# FINAL ENVIRONMENTAL IMPACT STATEMENT

## WESTCHESTER JOINT WATER WORKS RYE LAKE WATER FILTRATION PLANT Purchase Street, Harrison, New York

### September 28, 2022

**Figure 1-1: Site Location**

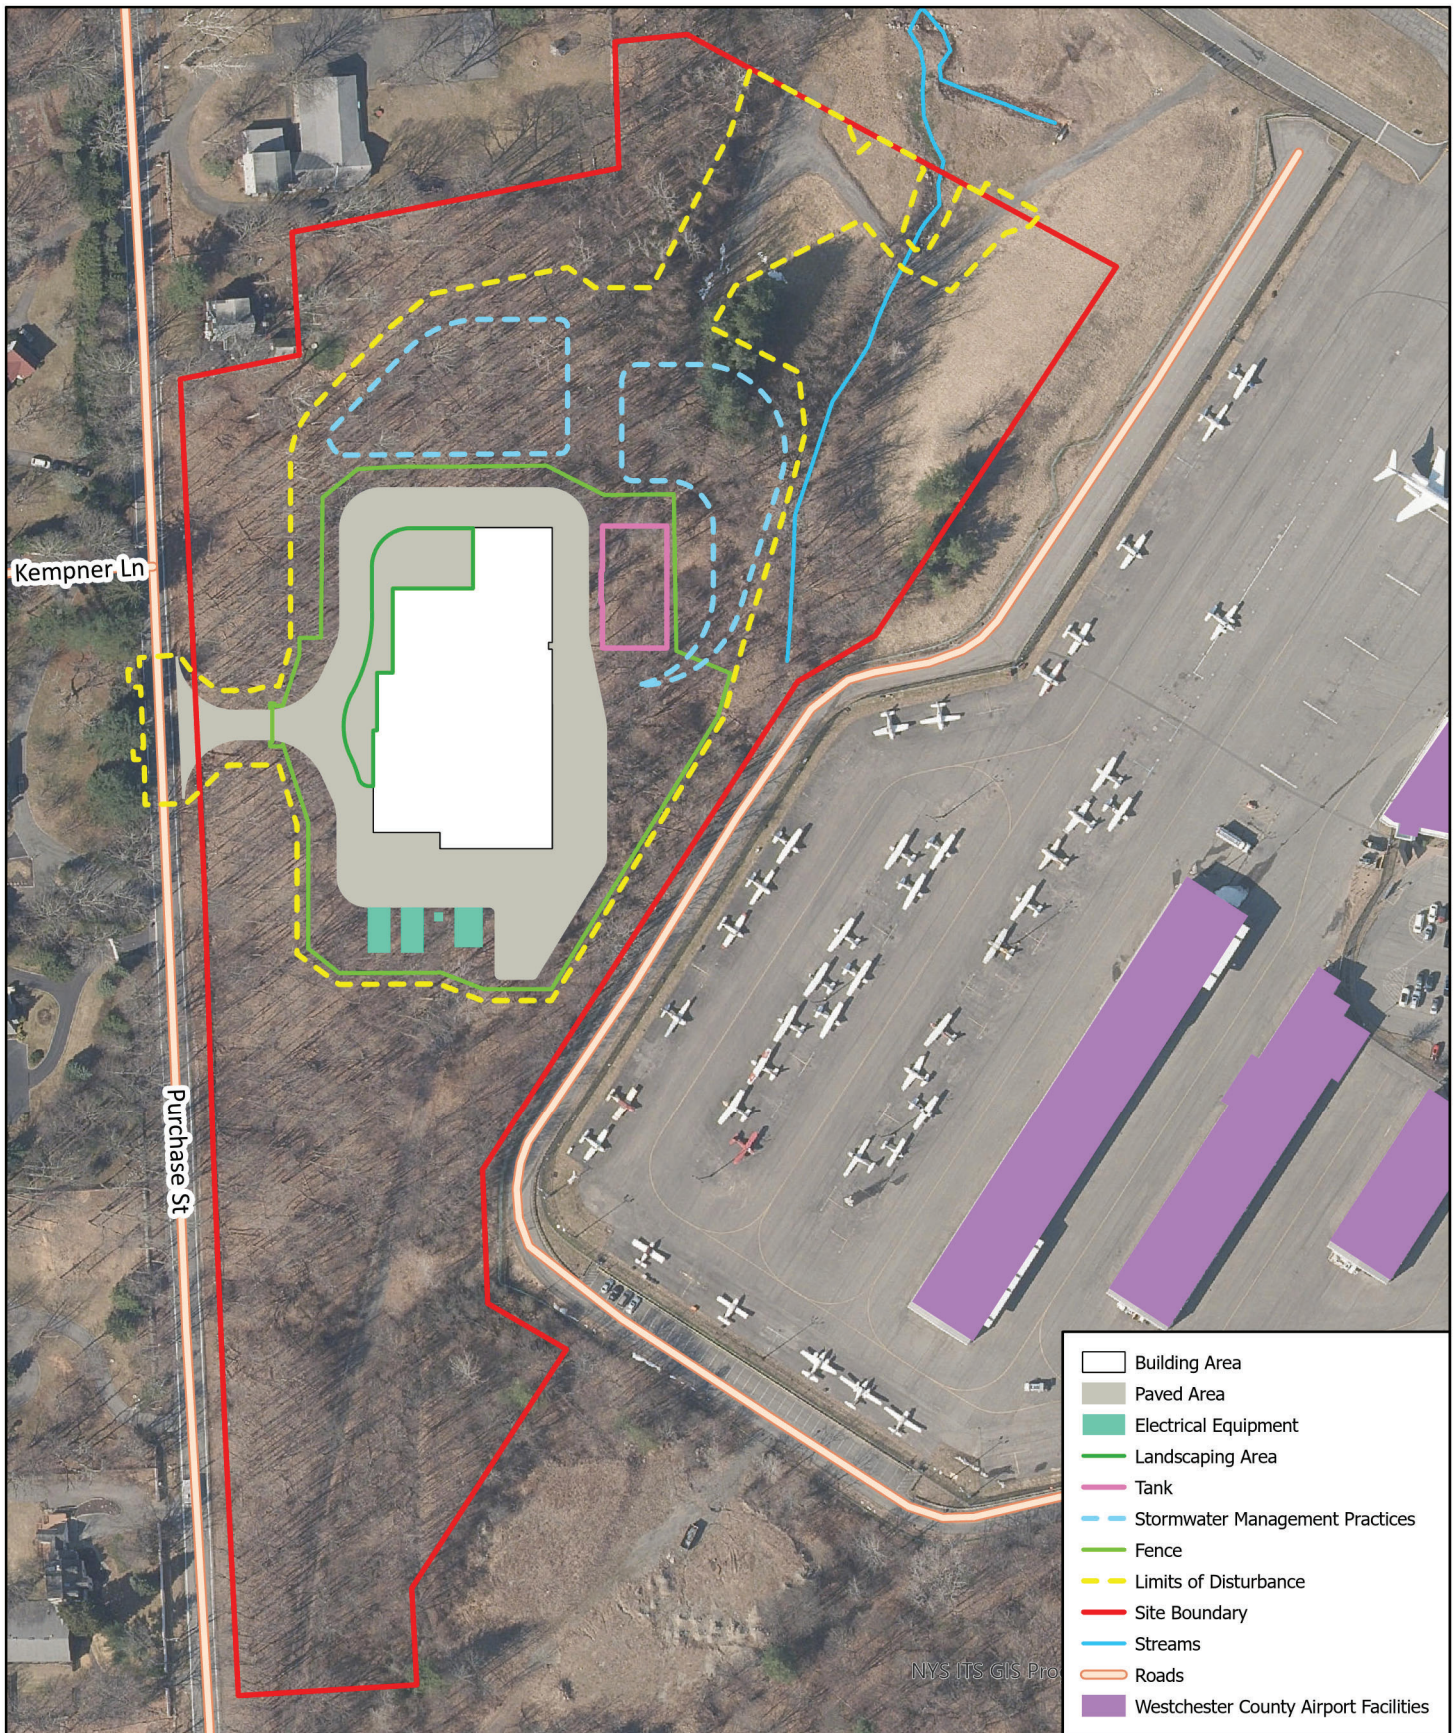
Please explain why a berm could not be built in place of this 10' tall perimeter fence. We believe an earthen berm will provide a much more effective sight and sound attenuation barrier than a chain-link fence. We believe that a chain-link fence will have no impact on sound and sight attenuation. We believe that the use of a large chain-link fence creates a view that worsens the visual impact of the filtration plant rather than improves it. Please explain how many more trees may need to be cleared to allow for the construction of a berm. Please explain if the Proposed Site is of sufficient size to allow the building of a 10' tall berm around the filtration plant.

An eight (8)-foot high fence, as required by NYSDOH, would surround the filtration plant and separate the plant from the airport property. The approximate location of the fence is depicted on **Figure 1-1, Site Location**. To mitigate any potential negative visual impact of the security fence along Purchase Street, the fence is setback from the property line by approximately 100 feet. Along the northern property boundary facing the Purchase Friends Meeting House property, the fence is setback approximately 230 feet from the property line. The creation of a berm would not replace the NYSDOH security fence requirements (**see Response 3A.2**). This is a mandatory requirement. In addition, depending on the length and width of the berm, additional tree removal and ground disturbance would be required which would increase the environmental impacts of the Project.

**Figure 3A-1 Details of proposed ornamental fence and gate**

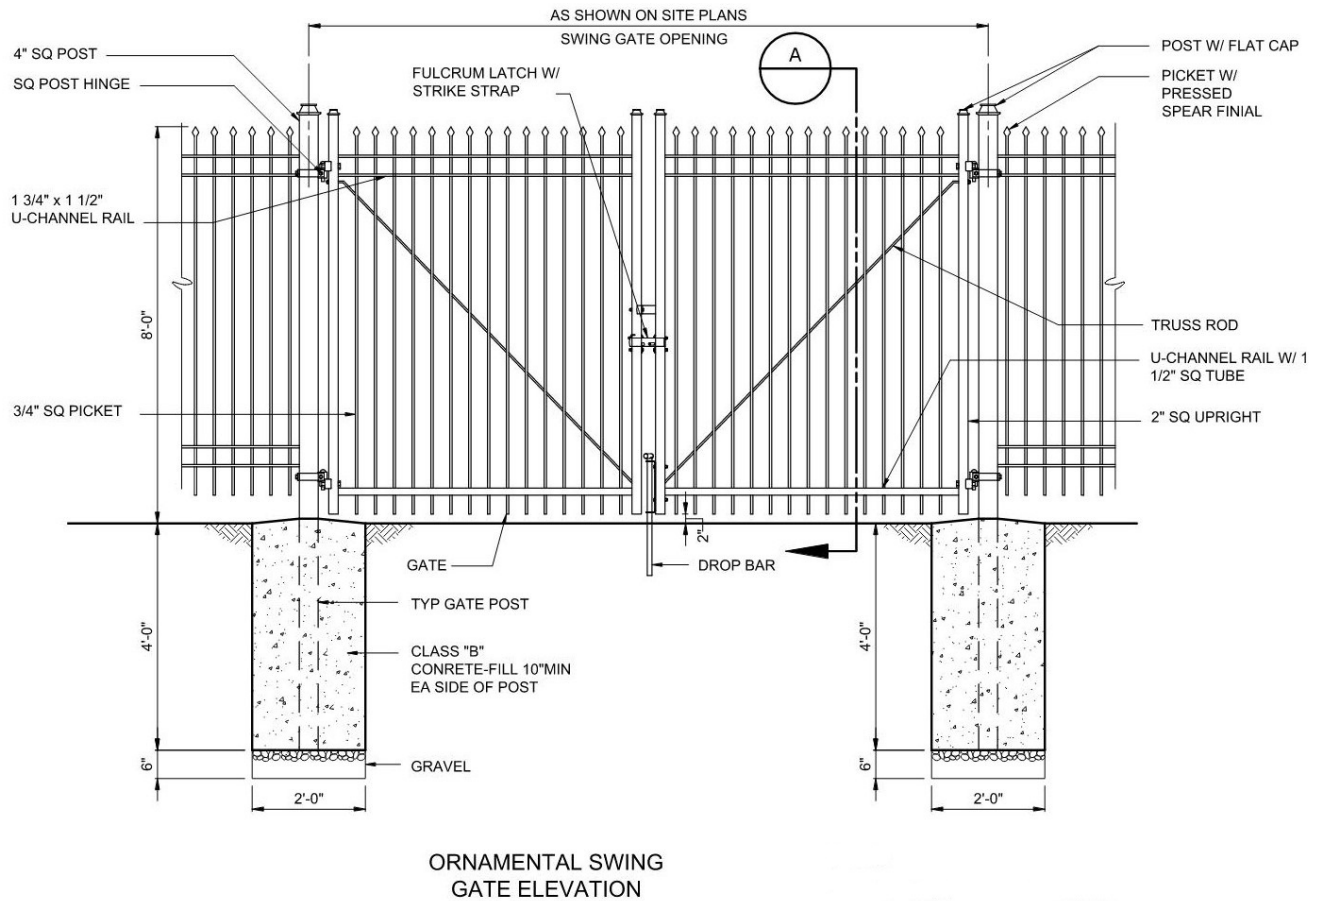
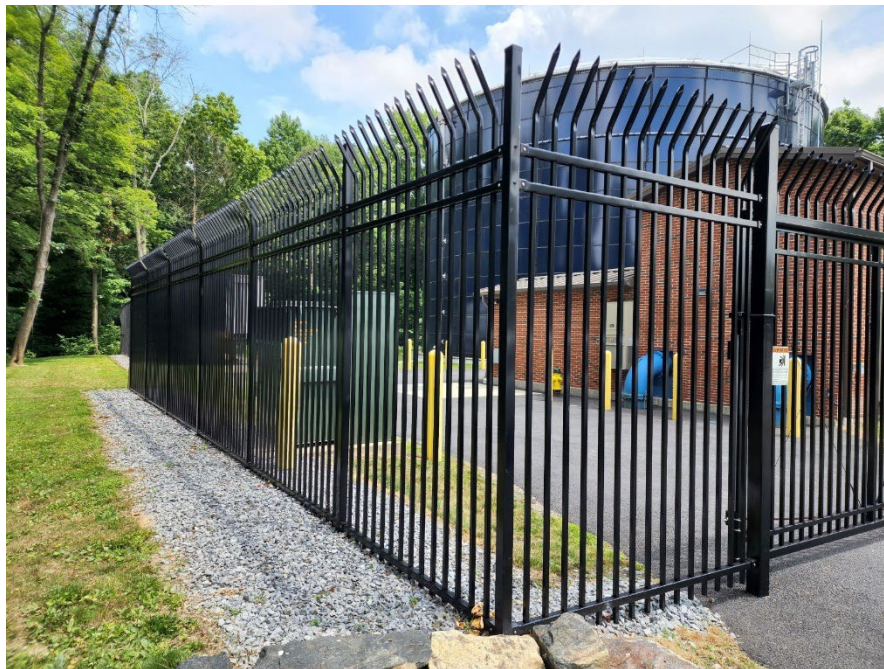
The DEIS [page 1-4, paragraph C] states that a 6' high retaining wall will be located on the southern side of the plant. Additionally, a 10' high fence will surround the filtration plant. Please set forth the purpose of the 6' high retaining wall and why it is not redundant to the 10' high fence.

Please state the nature of the 10' high fence and whether it is a chain-link fence or not. Please provide alternatives to having an industrial-style chain-link fence. Please consider making efforts to have this fence conform to the Town of Harrison zoning laws which require fences no higher than 4'/6' rather than applying for a variance from the Town of Harrison Planning Board and any other town, county and state boards to increase the height of the 4'/6' chain-link fence to 10'. Please explain to us, as your prospective new neighbors, why we should have to stare at several hundred feet of 10' high chain-link fence built 80' from our playground, meeting house and graveyard next door. Please explain why our neighbor Joe Billone's house will be 75 feet from this 10' tall chain-link fence. Please explain why our caretaker's apartment at the corner of our meeting house will be 100' from this 10' tall chain-link fence.

Presently, the Proposed site is bordered on two sides by old stone walls. We believe that similarly constructed stone walls would blend in more with the existing stone walls and better integrate the filtration plant site with the character of the surrounding neighborhood. Please explain why constructing a new similarly sized stone walls could not serve the same purpose as a 10' high chain-link fence.

The six (6)-foot high retaining wall will be located on the southern side of the plant by the emergency generators and is necessary as a result of the regrading of the southern portion of the site to level the area for the loop road and the electrical equipment. The fence is required by the New York State Department of Health (NYSDOH) for security purposes. NYSDOH recommends an eight (8)-foot chain link fence with three (3) feet of barbed wire for security fencing for all filtration plants. The Project proposes to install an eight (8)-foot spiked anti-climb ornamental fence along the northern and western portions of the facility in lieu of the barb wire. A request has been submitted to NYSDOH to install this ornamental fence as a substitute for the recommended eight (8)-foot

chain link fence with three (3) feet of barbed wire. **Figures 3A-1 and 3A-2** provide information on the proposed fence details and an example of it already installed at another WJWW facility.
